Appendix 2 – Amended Scheme Clarification Note.

- 1.1. **Refused Scheme** – Site Layout and Landscape Strategy, drawing number P19-2022_10 Rev Q, dated 18/08/2022, prepared by Pegasus Group.
- 1.2. **Amended Scheme** – Amended Scheme Site Layout and Landscape Strategy, drawing number P19-2022_24 Rev C, dated 29/02/2024, prepared by Pegasus Group.

Amendment A.

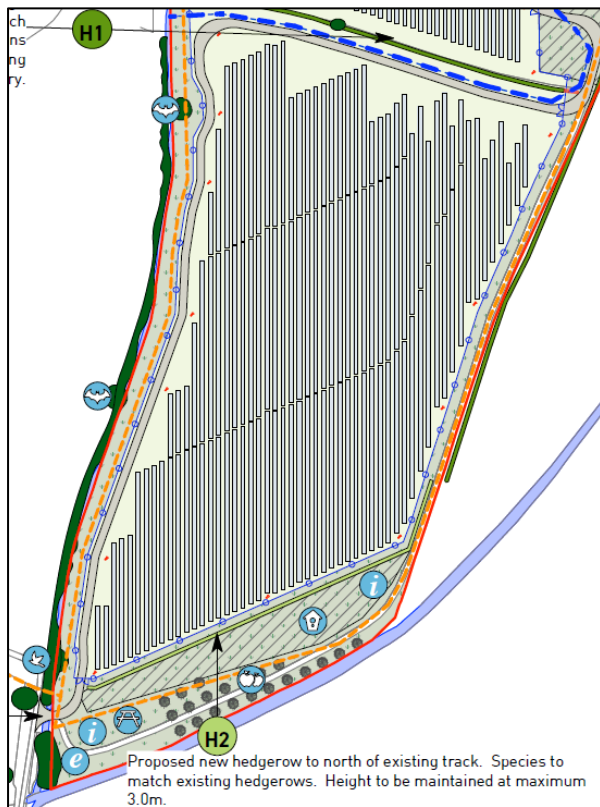
Refused Scheme – The PRoW alignment as per dataset provided by the Council was unrepresentative of the on the ground alignment.

Amendment A – The PRoW alignment has been corrected on the Amended Scheme Plan.

Amendment B.

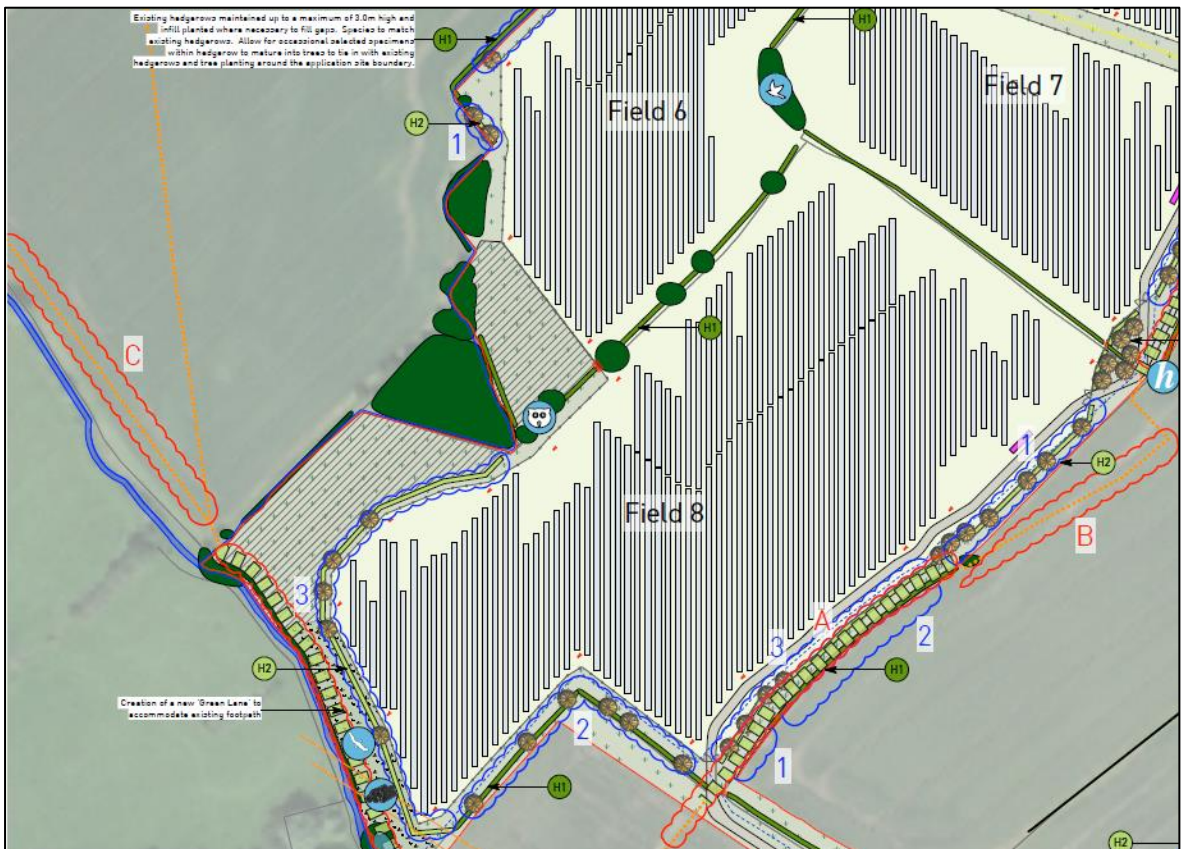
Refused Scheme - The Arboricultural survey had shown a hedgerow offsite, which is no longer present.

Amendment B - On the Amended Scheme Plan the hedgerow notation has been updated to reflect that this offsite hedgerow is no longer present.

Amendment C.

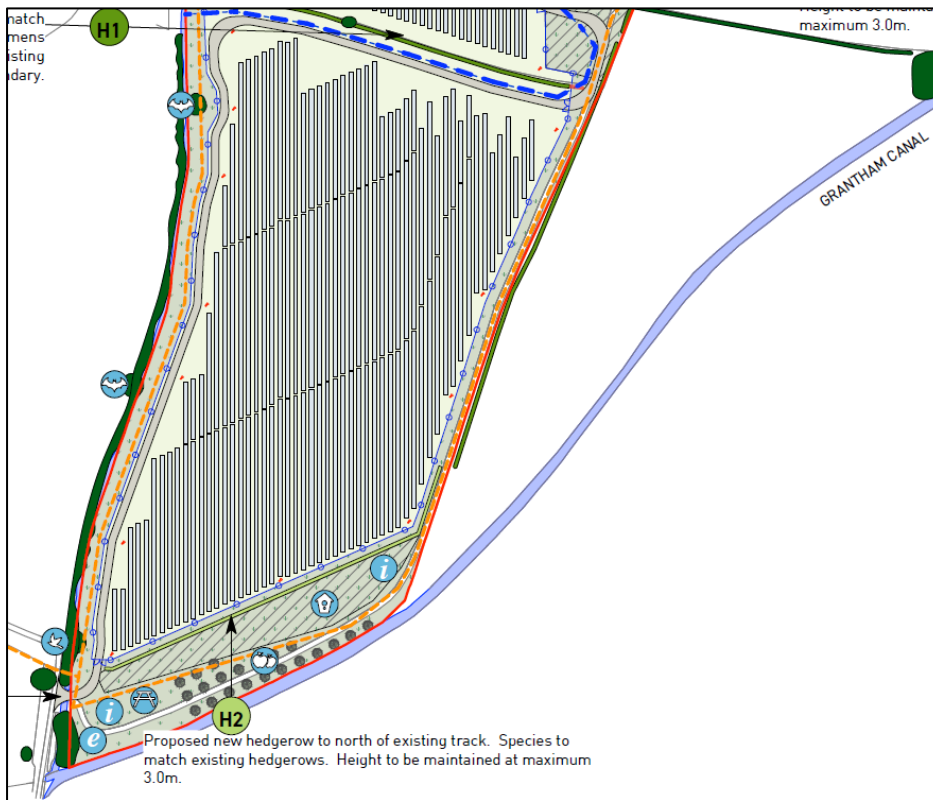
Refused Scheme – This offsite PRoW was not shown on the Refused Scheme.

Amendment C – This offsite PRoW has now been shown on the Amended Scheme Plan.

Amendment D.

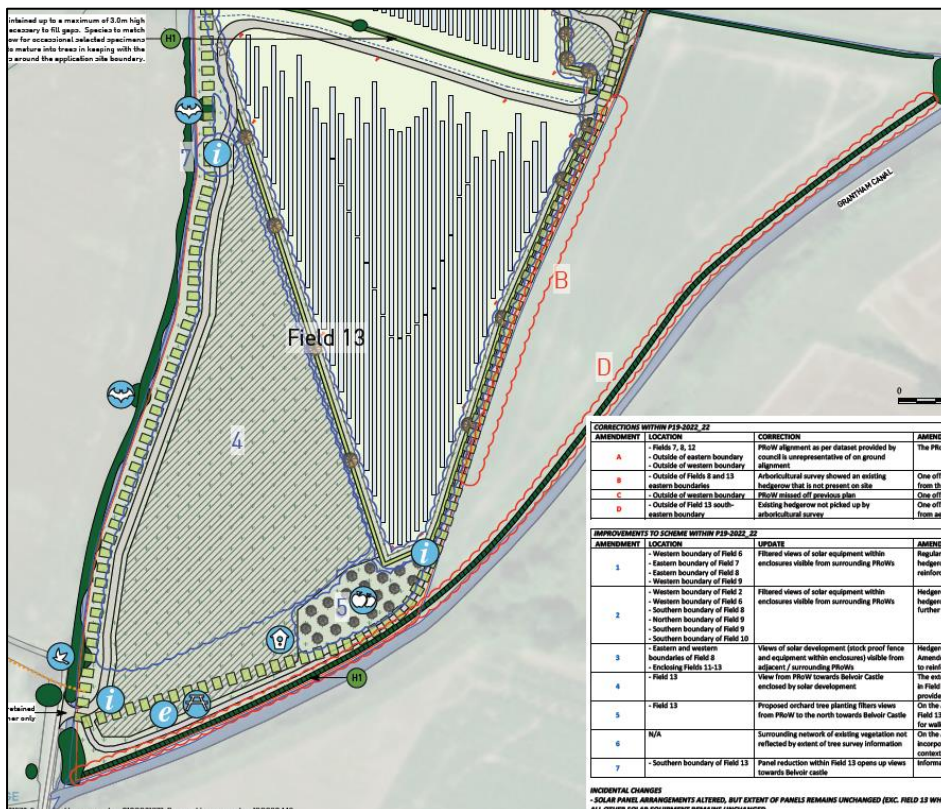
Refused Scheme – The existing offsite hedgerow to the north of the canal was not shown.

Amendment D – The existing offsite hedgerow to the north of the canal has now been shown on the Amended Scheme Plan.

Amendment 1.

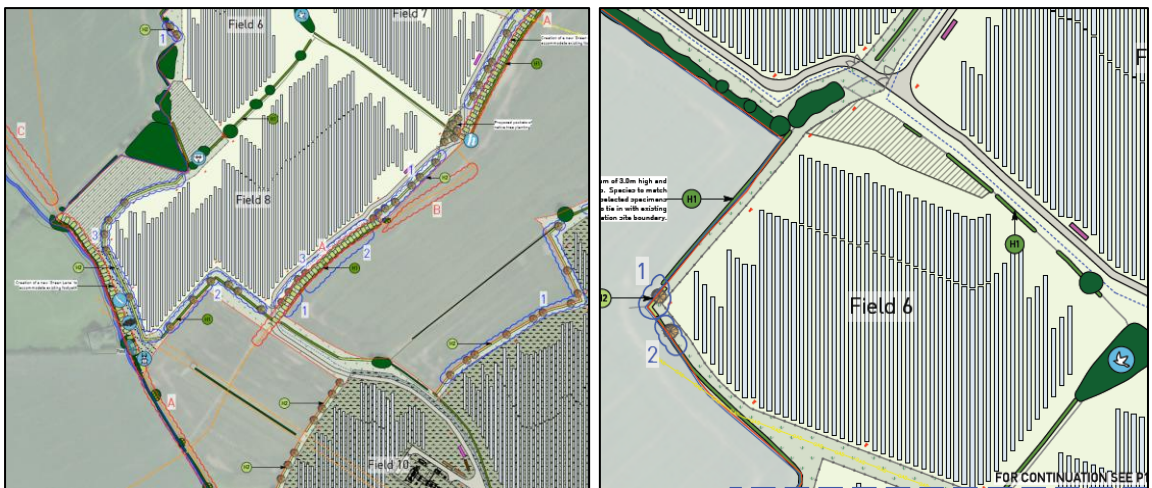
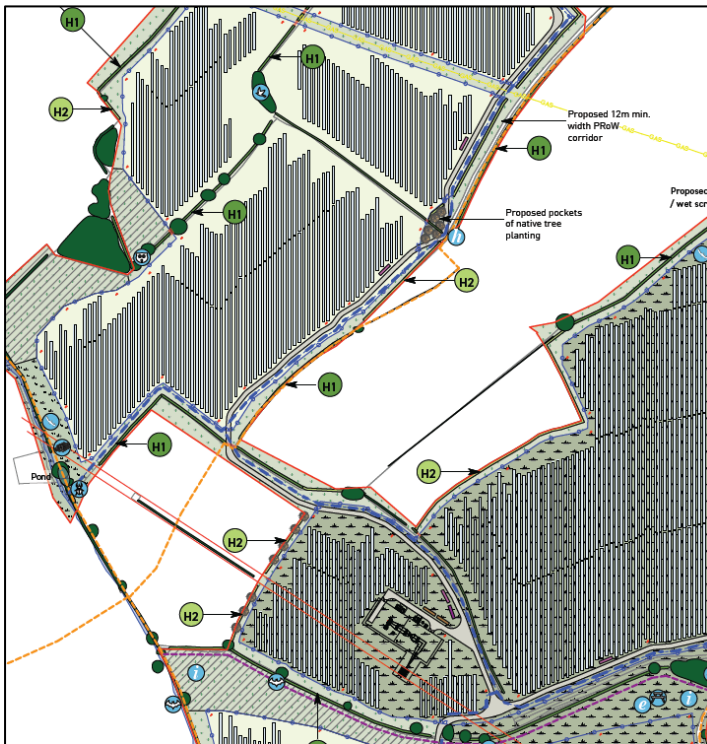
Refused Scheme – Some filtered views of solar equipment within enclosures would be visible from surrounding PRoWs.

Amendment 1 – To further reinforce hedgerows, regular hedgerow trees have now been added in Fields 6–9 on the Amended Scheme Plan.

Amendment 2.

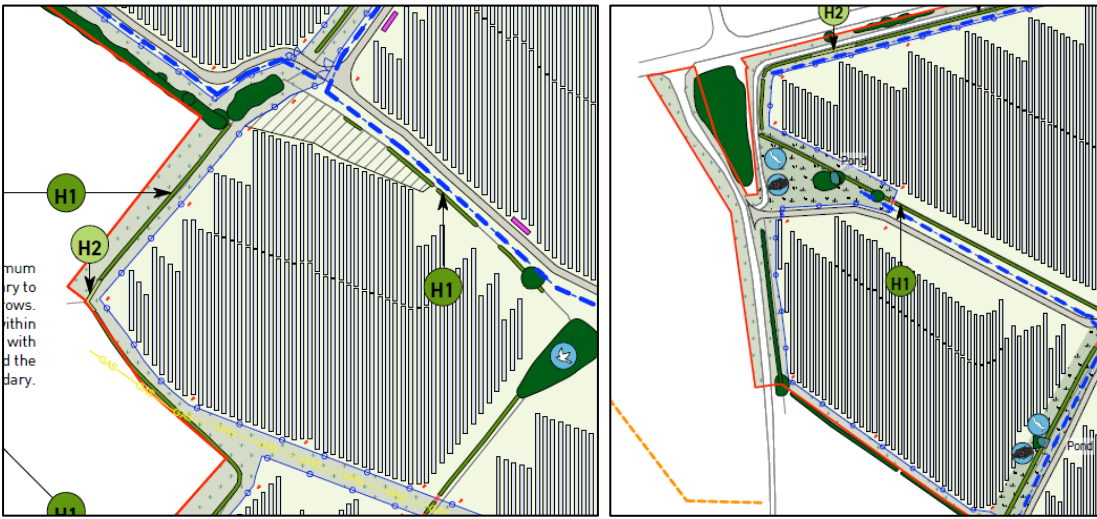
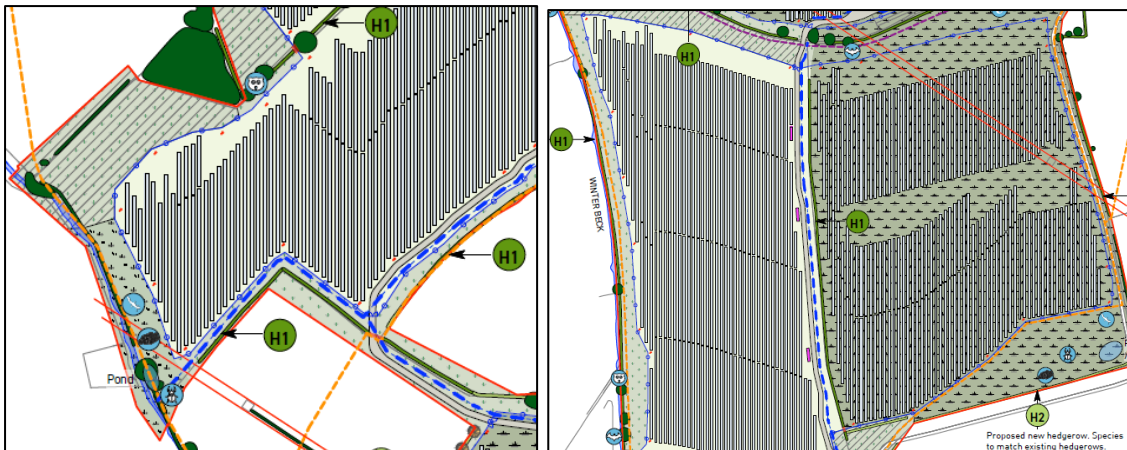
Refused Scheme – Some filtered views of solar equipment within enclosures would be visible from surrounding PRoWs.

Refused Scheme – Some filtered views of solar equipment within enclosures would be visible from surrounding PRoWs.

Amendment 2 – To further reinforce hedgerows, hedgerow trees have now been added in Fields 2, 6 and 8-10 on the Amended Scheme Plan.

Amendment 2 – To further reinforce hedgerows, hedgerow trees have now been added in Fields 2, 6 and 8-10 on the Amended Scheme Plan.

Amendment 3.

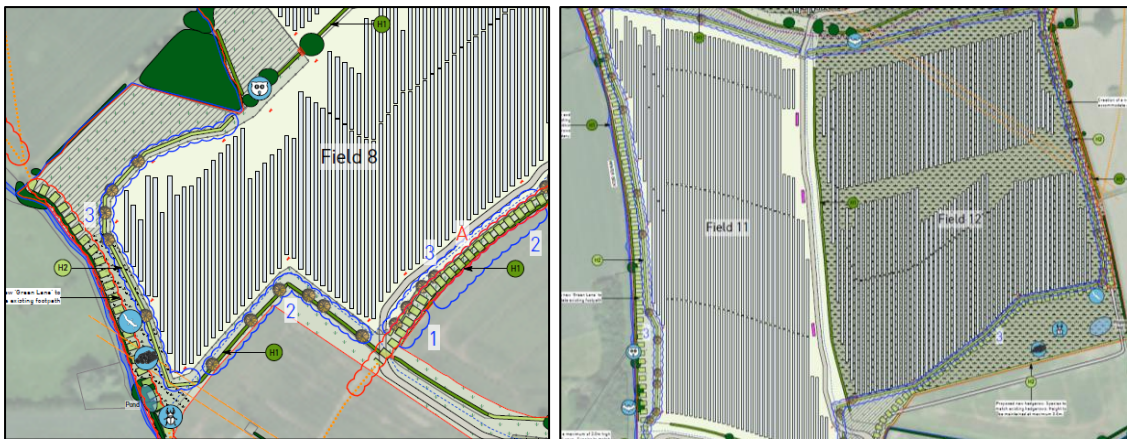
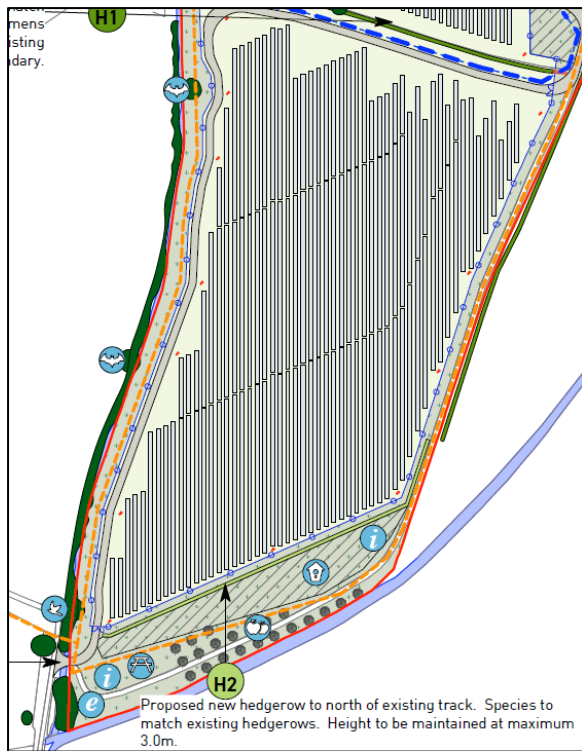
Refused Scheme – Views of the solar development (stock proof fence and equipment within enclosures) would be visible from some PRowWs.

Amendment 3 – To reinforce hedgerows, hedgerows with regular hedgerow trees have now been proposed on the Amended Scheme Plan along the fence lines in Fields 8, 11, 12 and 13.

Amendment 4.

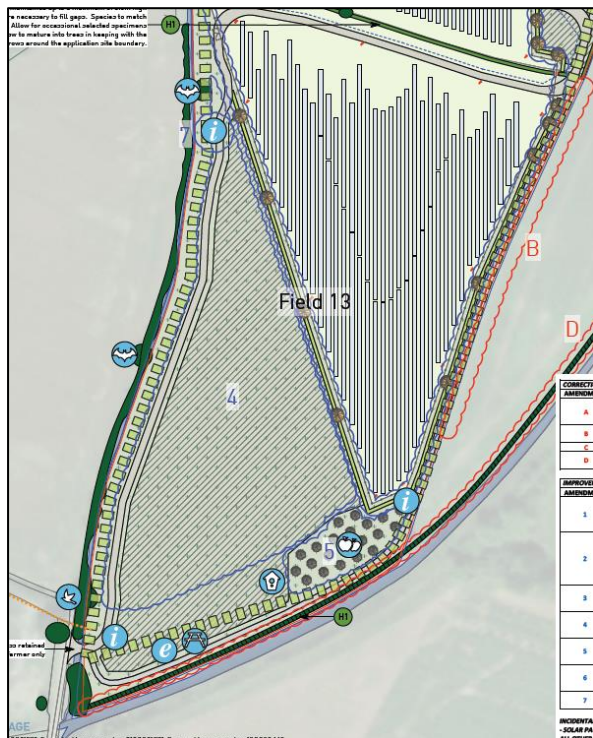
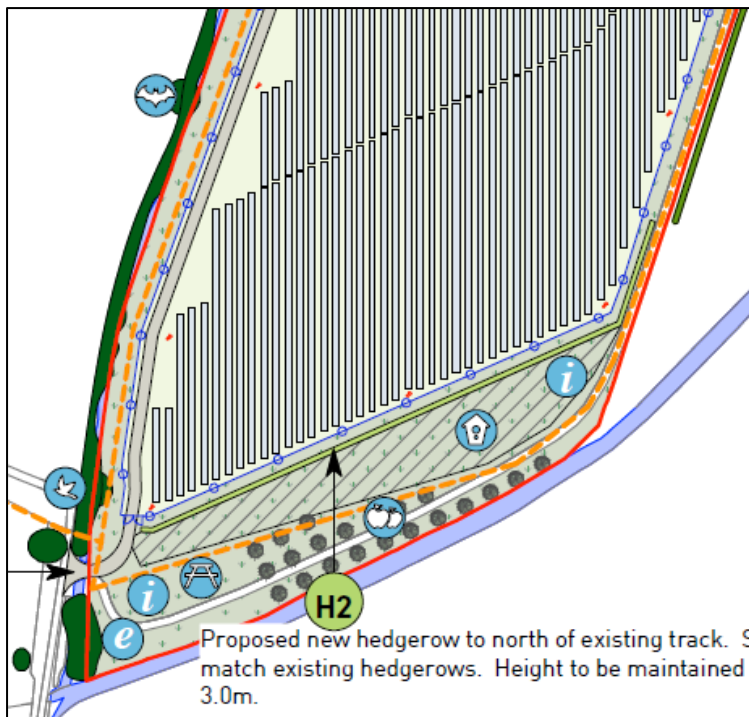
Refused Scheme – View from the PRoW towards Belvoir Castle were enclosed by the solar development.

Amendment 4 – The extent of solar panels has been reduced (by just over 2.2 hectares) in Field 13 on the Amended Scheme Plan to retain the view towards Belvoir Castle and to provide an extended area which will be suitable as a Skylark nesting area.

Amendment 5.

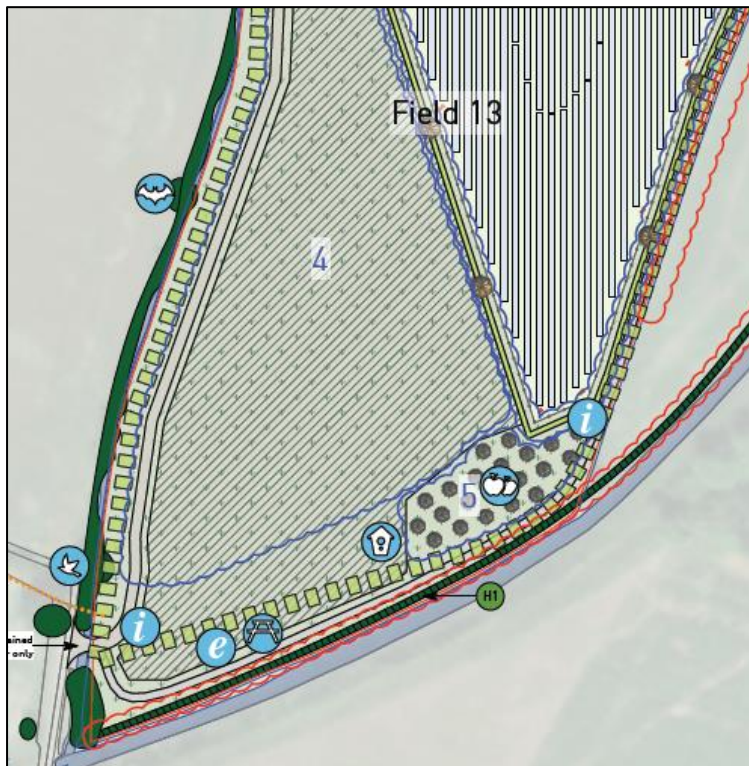
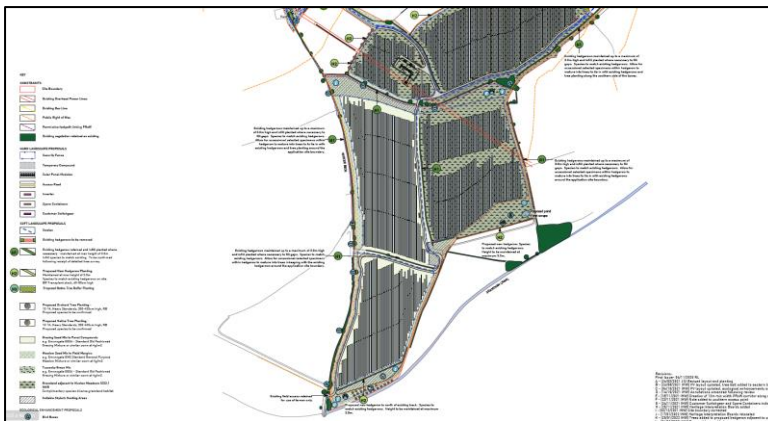
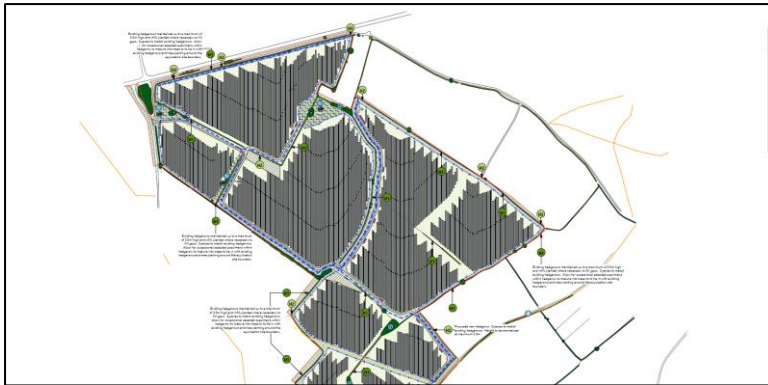
Refused Scheme – Proposed orchard tree planting would filter views from the PRoW to the north towards Belvoir Castle.

Amendment 5 – On the Amended Scheme Plan the proposed orchard tree planting in Field 13 has now been moved eastward to open up views of Belvoir Castle for walkers and users of the recreational area.

Amendment 6.

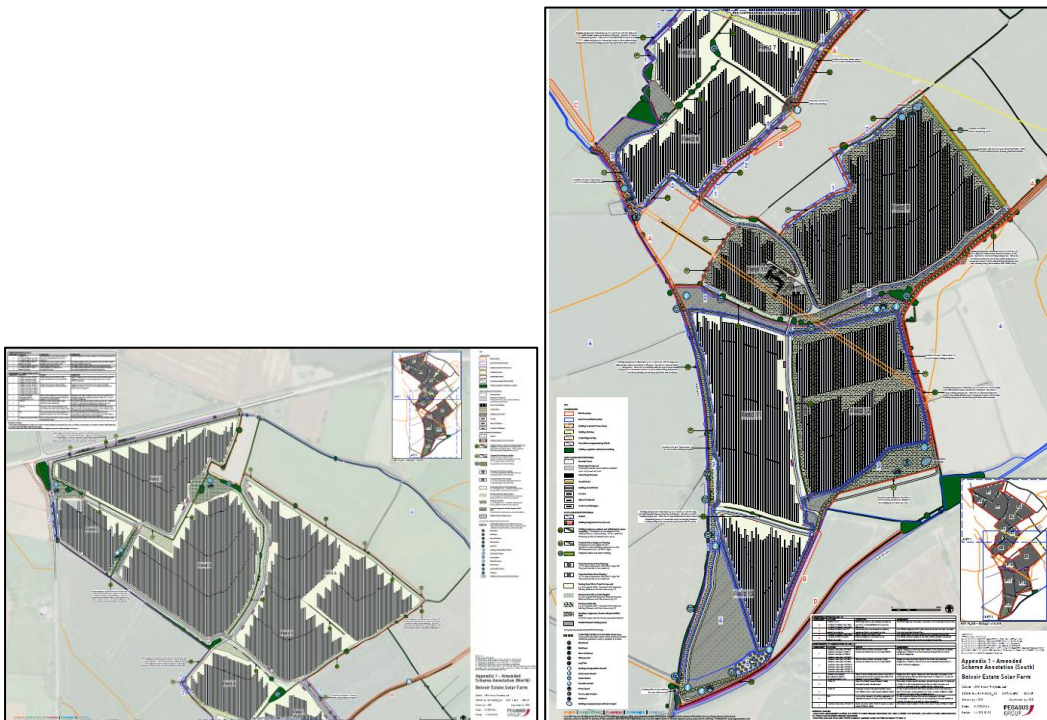
Refused Scheme – The surrounding network of existing vegetation was not shown.

Amendment 6 – To provide additional context of the screening provided by nearby vegetation, this is now shown on the Amended Scheme Plan.
